SEQUOYAH NUCLEAR PLANT (SQN) UNITS 1 AND 2, AND WATTS BAR NUCLEAR PLANT (WBN) UNIT 1 RESPONSE TO NRC BULLETIN 2001-01, "CIRCUMFERENTIAL CRACKING OF REACTOR PRESSURE VESSEL HEAD PENETRATION NOZZLES," DATED AUGUST 3, 2001

**SEQUOYAH NUCLEAR PLANT (SQN) UNITS 1 AND 2 RESPONSE TO  
NRC BULLETIN 2001-01, "CIRCUMFERENTIAL CRACKING OF REACTOR PRESSURE  
VESSEL HEAD PENETRATION NOZZLES"**

**WATTS BAR NUCLEAR PLANT (WBN) UNIT 1  
RESPONSE TO  
NRC BULLETIN 2001-01, "CIRCUMFERENTIAL CRACKING OF REACTOR PRESSURE VESSEL  
HEAD PENETRATION NOZZLES"**

General Arrangement In Upper Reactor Cavity Area

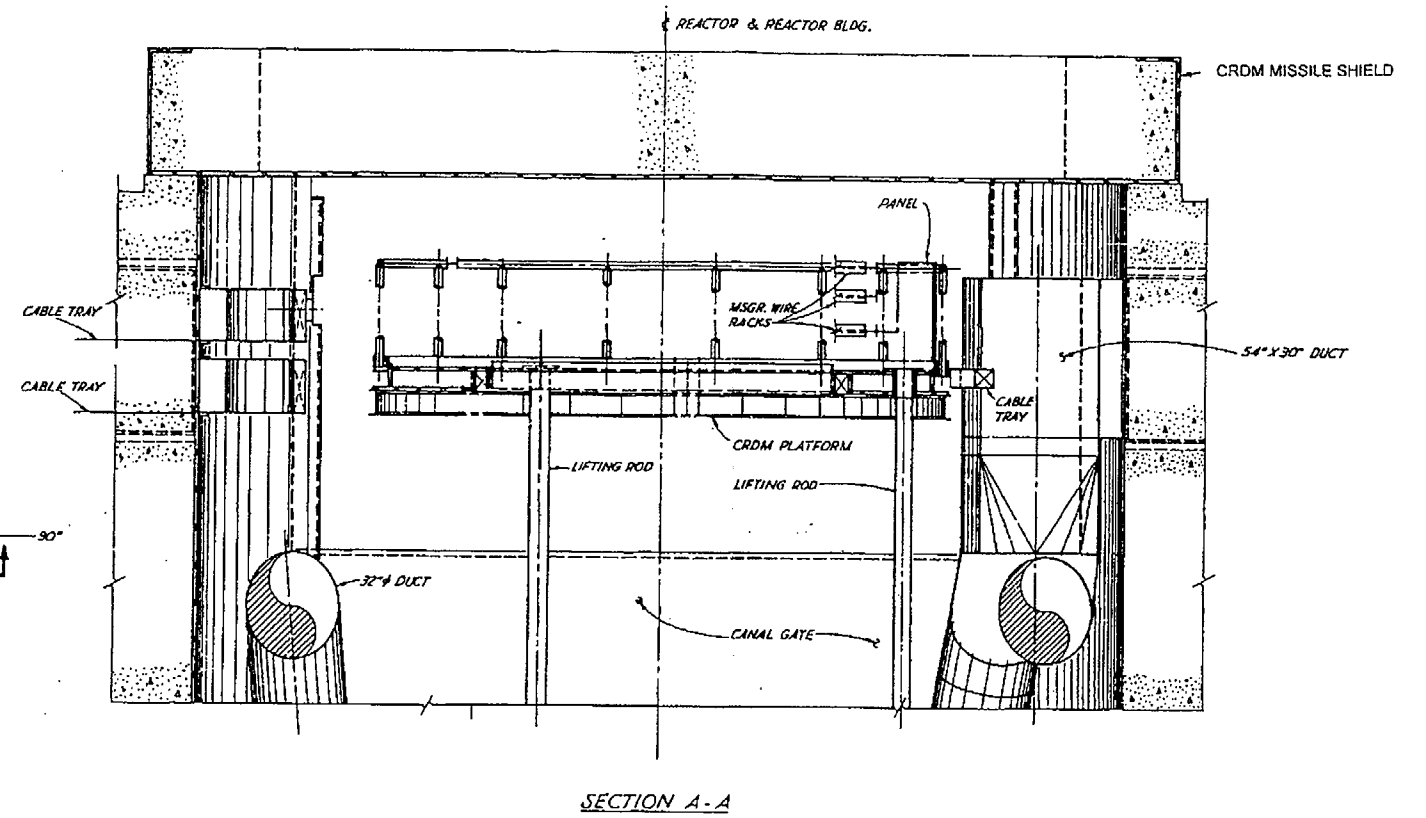
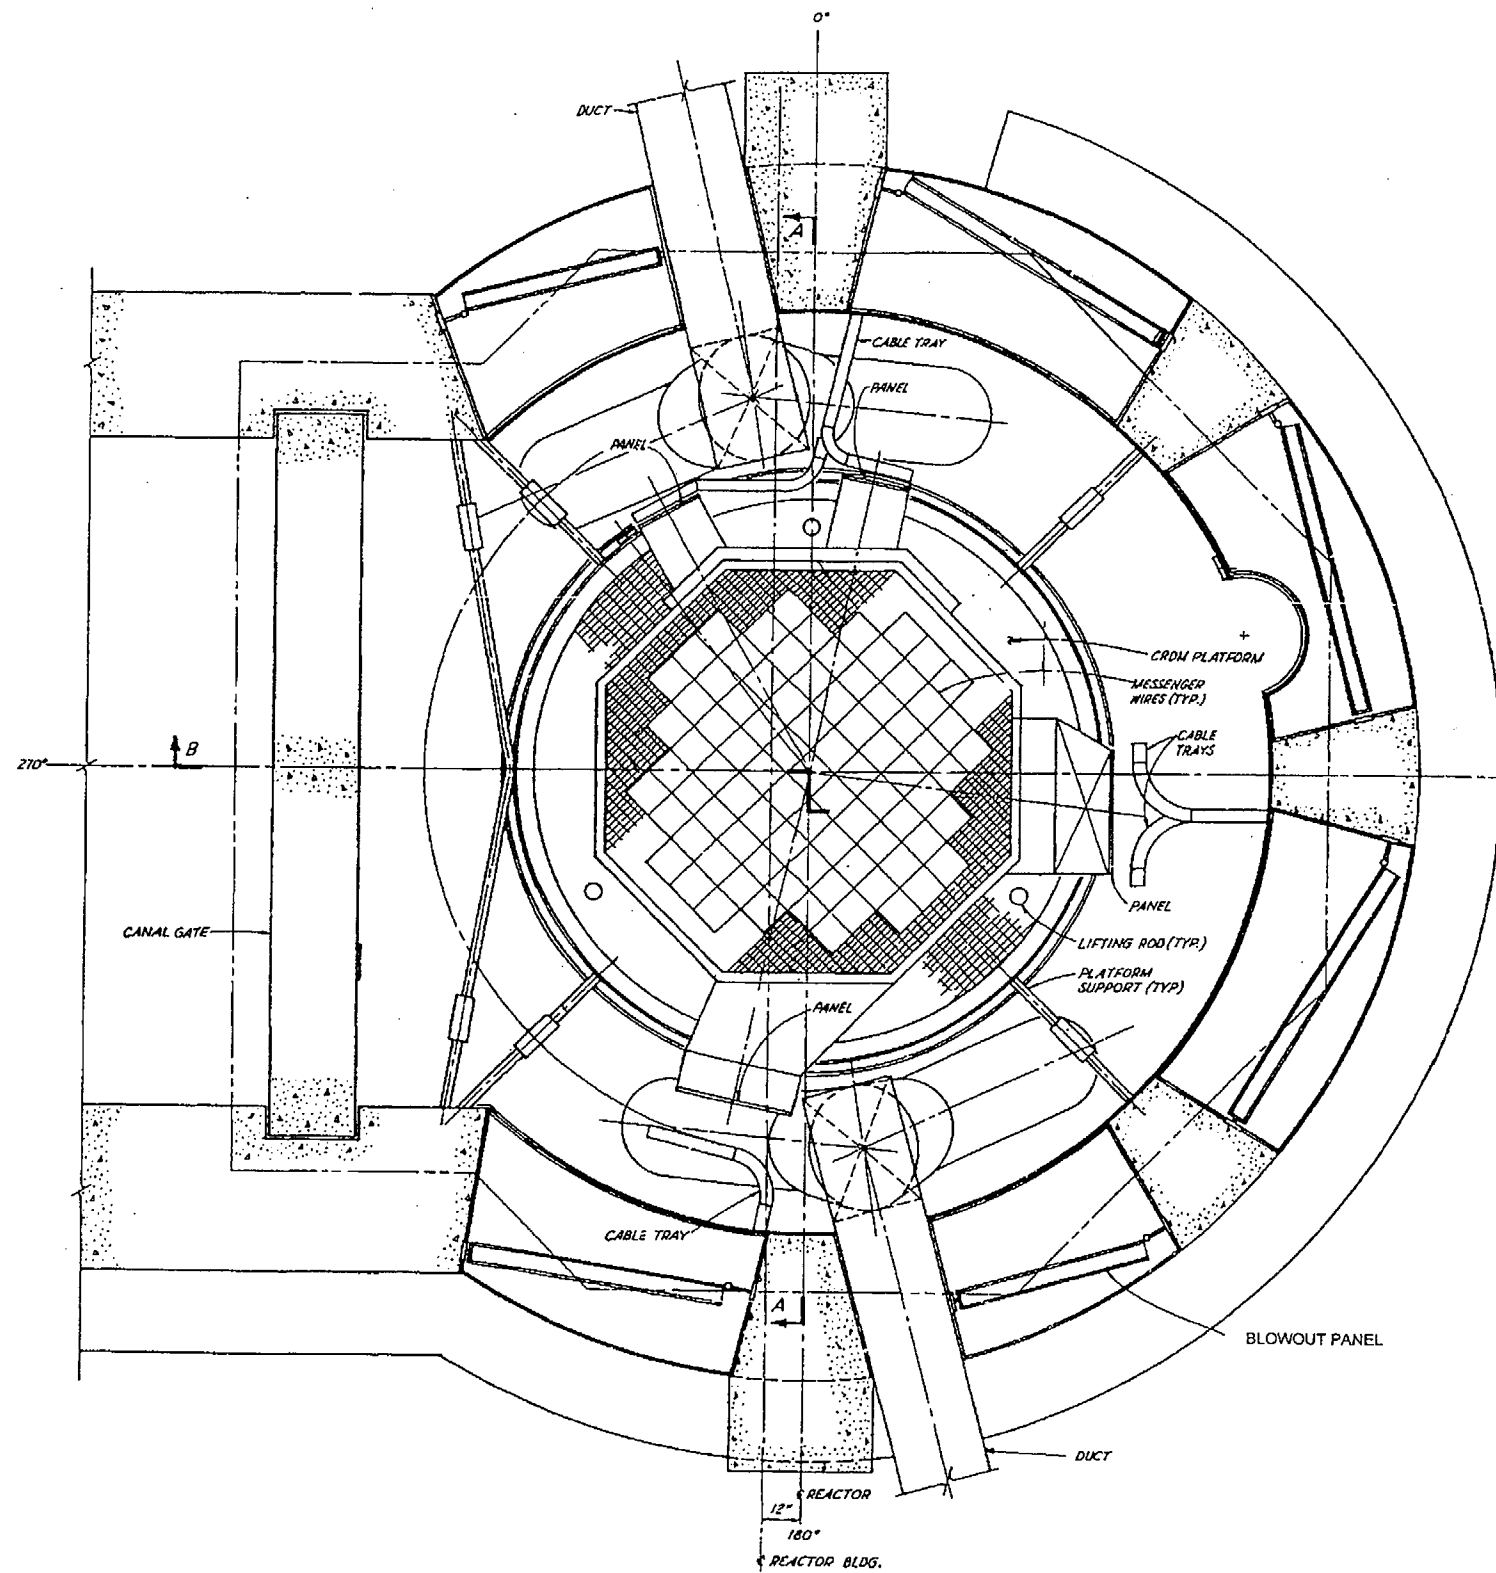
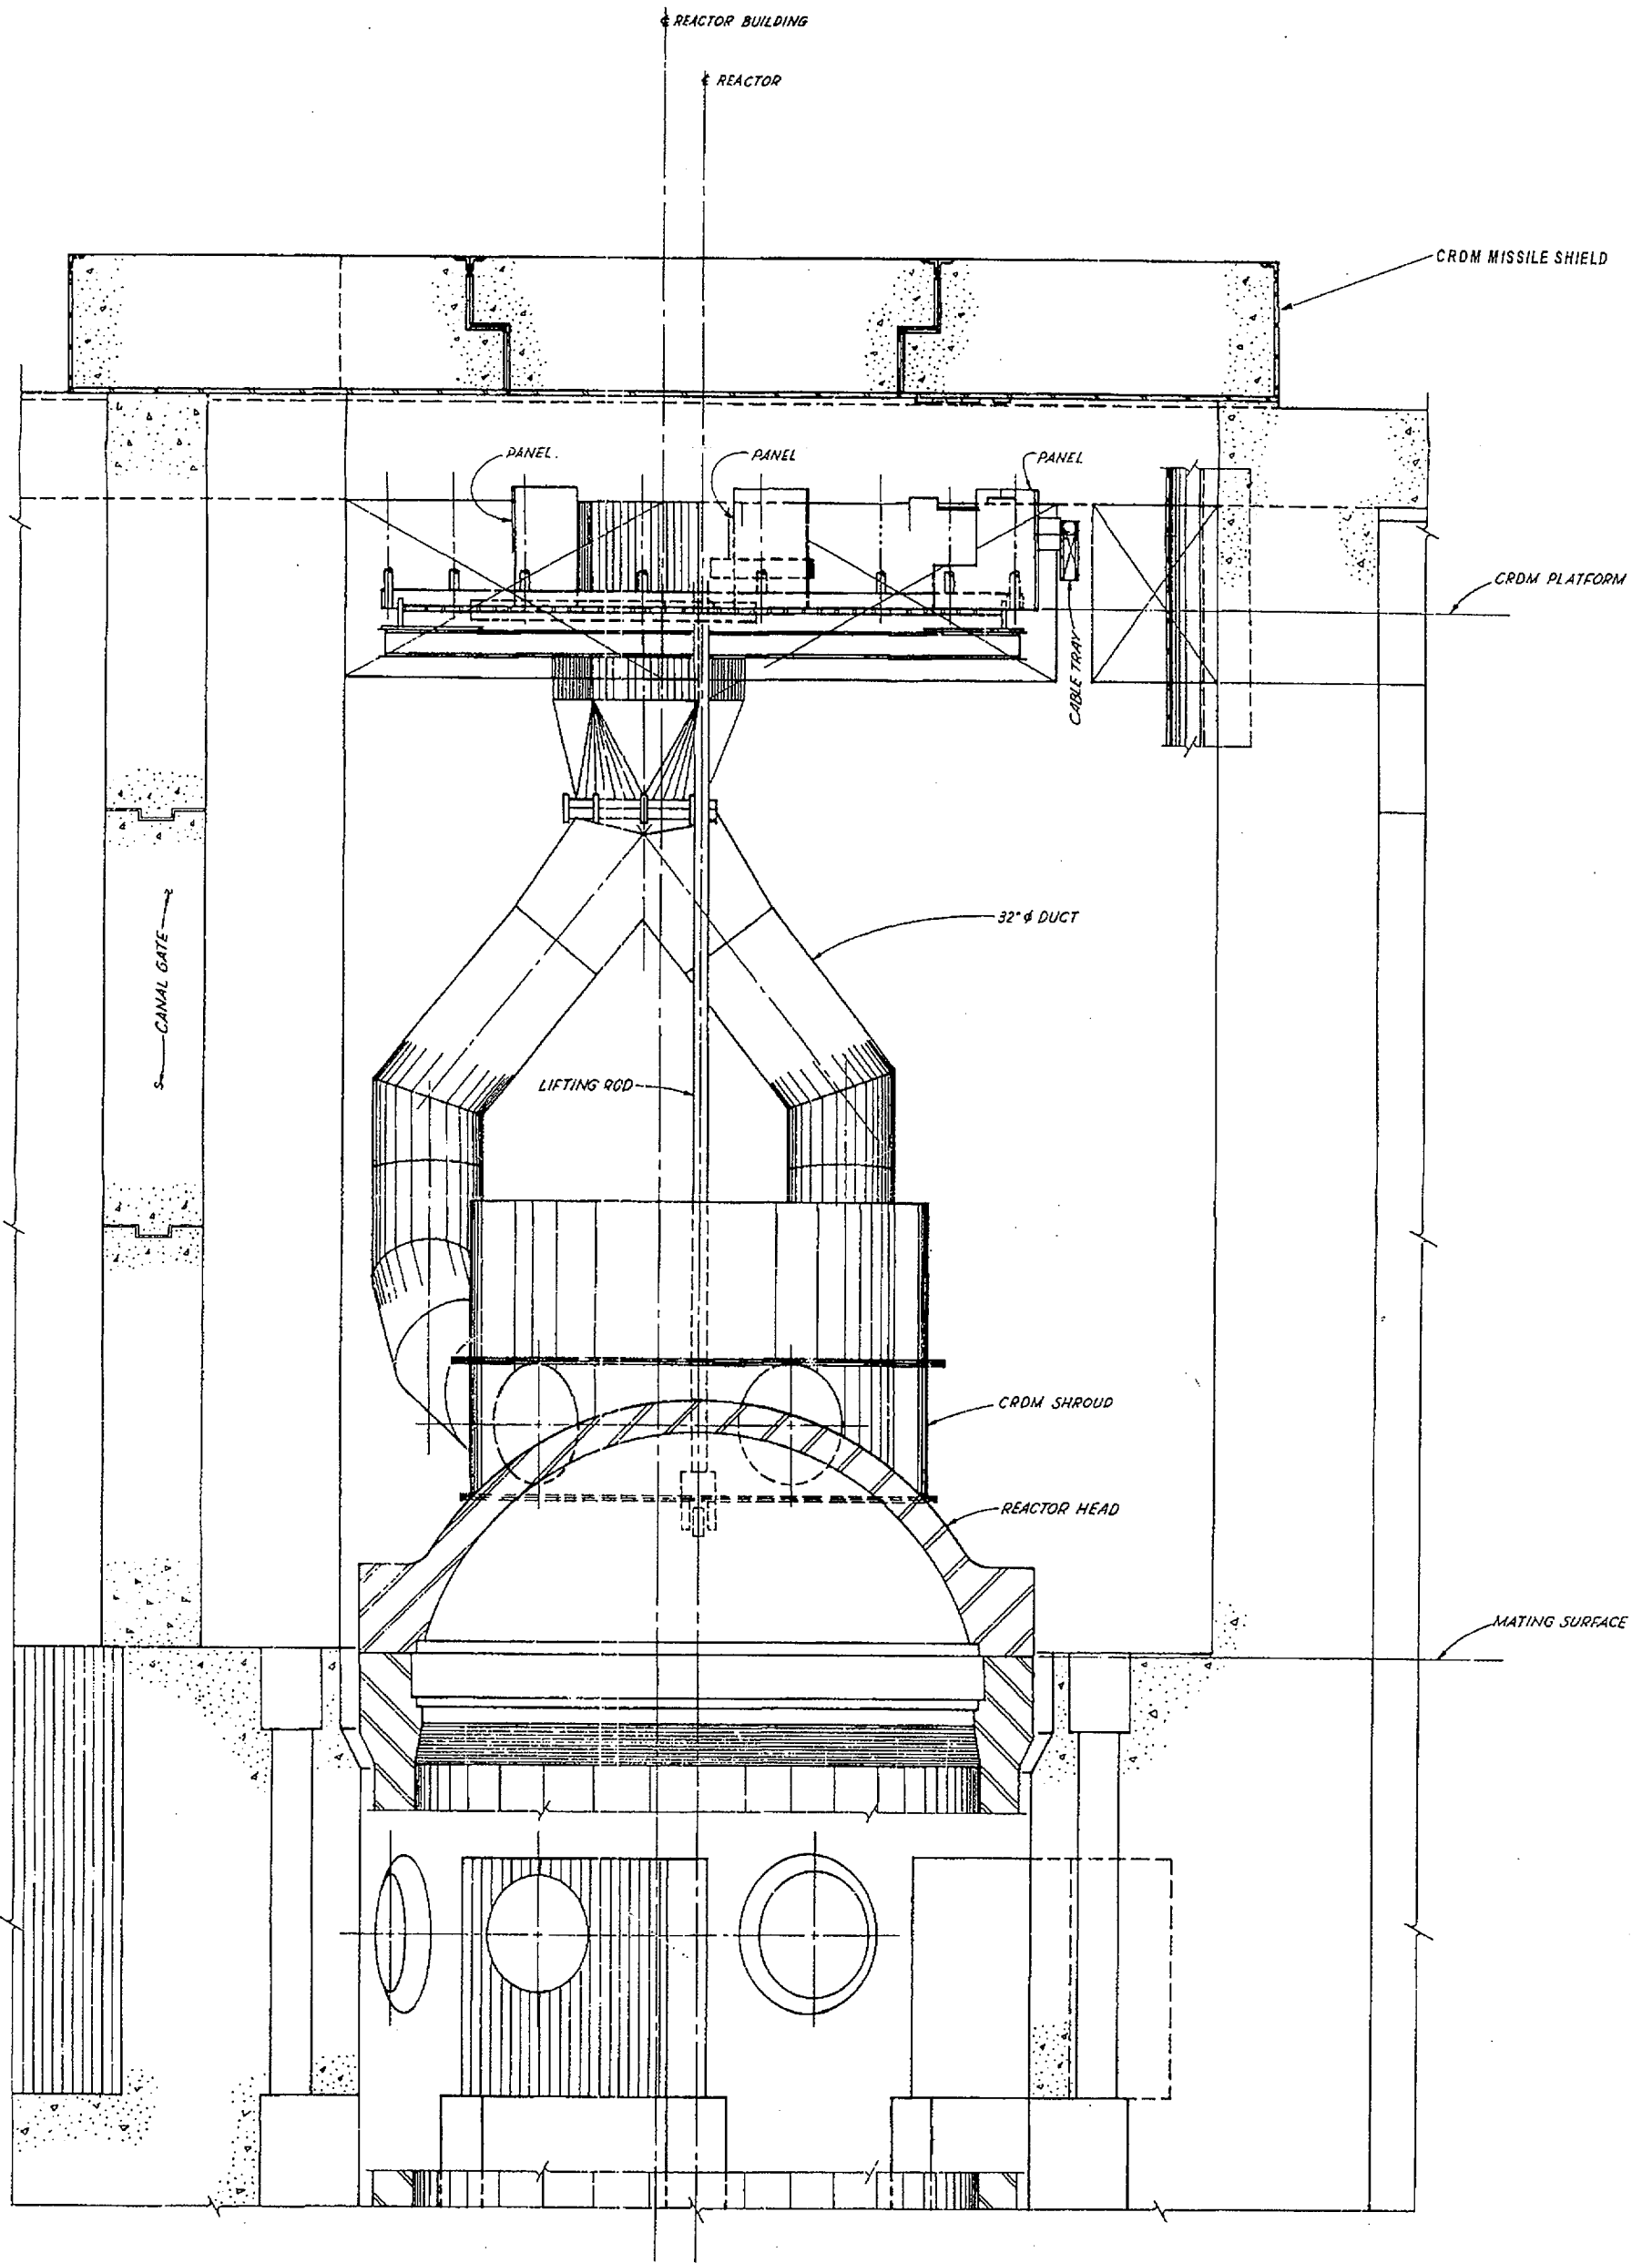
- e. a description of the configuration of the missile shield, the CRDM housings and their support/restraint system, and all components, structures, and cabling from the top of the RPV head up to the missile shield. Include the elevations of these items relative to the bottom of the missile shield.

Enclosure 2, Attachment 1 provides a table that contains the general description of the components within the area of the upper reactor cavity between the RPV head and the CRDM missile shields. Refer to Enclosure 2, Attachment 2 for a sketch of the general arrangement in this area.
